Assessment Officer Report

PA2403077

161 Central Road, Nunawading

Officer Assessment Report
Development Approvals & Design

Figure 13 Plan of Subdivision 737975T (relevant easements highlighted)

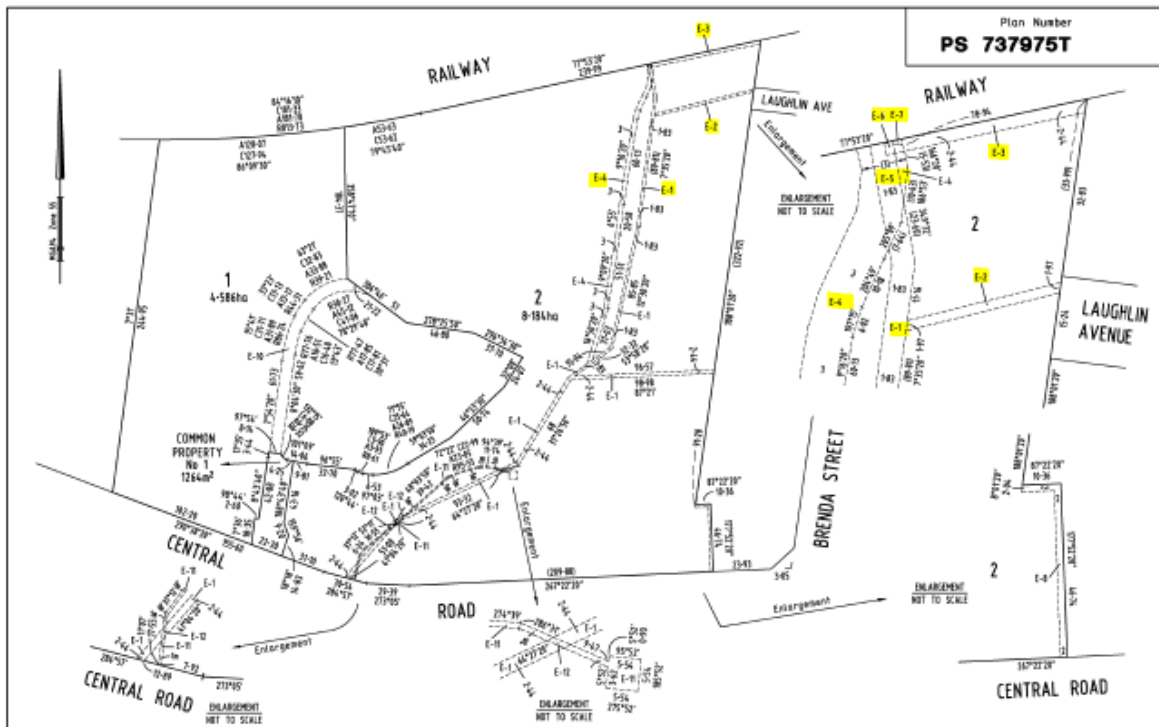
This application does not propose the construction of any buildings over these easements, and access will be maintained following the development.

Figure 17 Location of existing trees and development encroachment

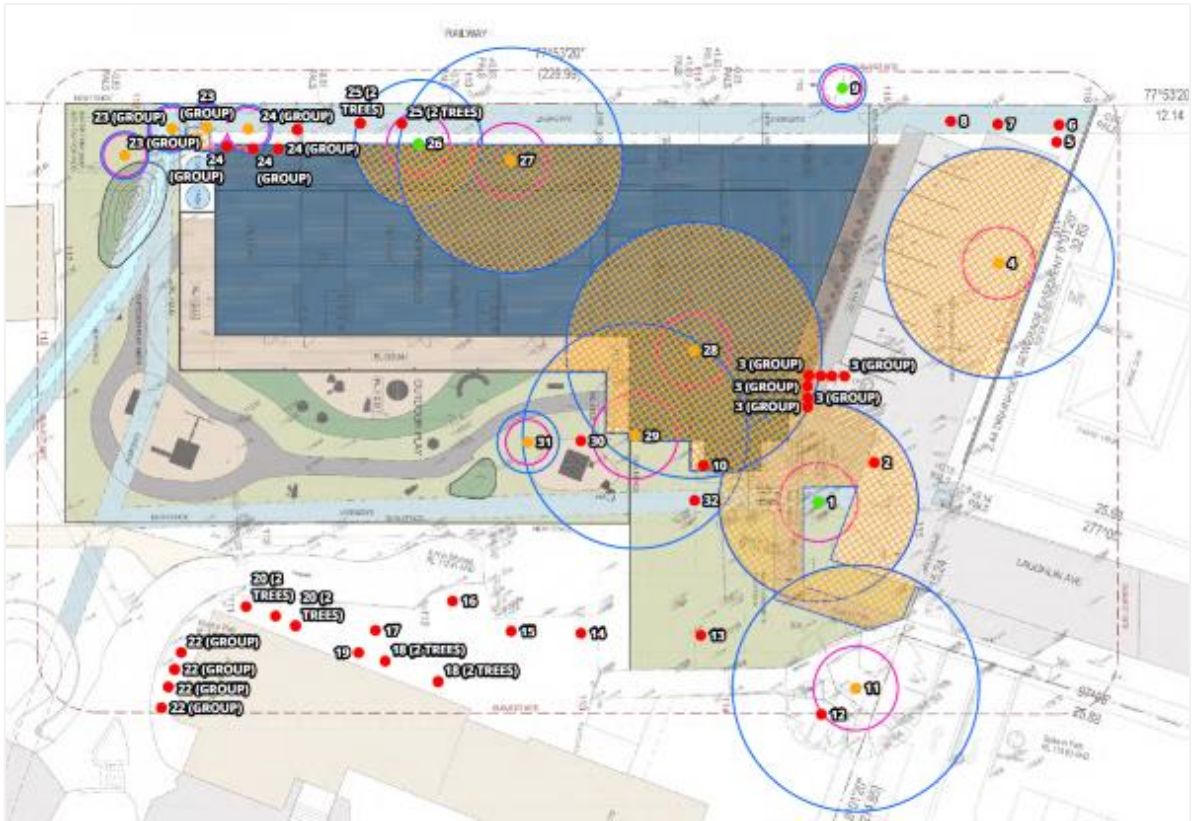
81. A total of seven trees proposed for removal trigger the need for planning permission under the Environmental Significance Overlay – Schedule 1, three of which are native vegetation (Trees 1, 28, 29) and four are indigenous species which have been planted (Trees 23, 24, 25 and 26).

87. Twelve of the trees triggering consent under the overlay are exotic species, do not provide indigenous vegetation on the site and trigger consent for removal based on their size only (specifically trees 2, 4, 5, 6, 13, 14, 15, 16, 27, 30, 31, and 32). While these trees contribute to the vegetation character and canopy coverage in the area, the submitted arborist report does not deem any of these trees to have a high retention value.

88. The remaining five trees (Tree 1, 23, 26, 28 and 29) are indigenous or native species and are considered to have moderate or high retention value. These trees are within the development footprint or will be significantly encroached upon and cannot be retained based on the proposed design response. The removal of these trees is considered generally acceptable, based on the extent of vegetation to be retained and planted on the site, which will provide for the enhancement of landscape quality and vegetated character as encouraged by the overlay.

90. The proposed development is appropriately separated from site boundaries, allowing for retention of some trees and planting within development setbacks. The submitted arborist report and landscape plan have been reviewed by Whitehorse City Council's Landscape department who are generally supportive of the proposal, pending updates to some proposed planting species to be reflect native species to be lost. Overall, the development outcome and removal of these trees is considered acceptable.
